## Proposal for amendments to ECE/TRANS/WP.29/2017/10

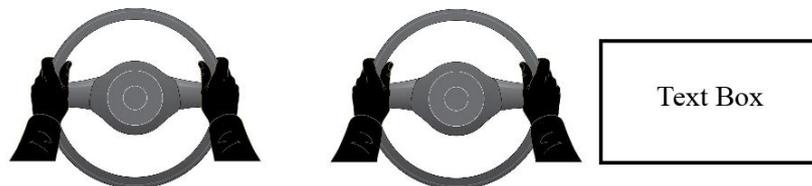
**The optical warning signal shall indicate to the driver to place their hands on the steering control. It shall consist of pictorial information showing hands and the steering control and may be accompanied by additional explanatory text or warning symbols- see examples below:**
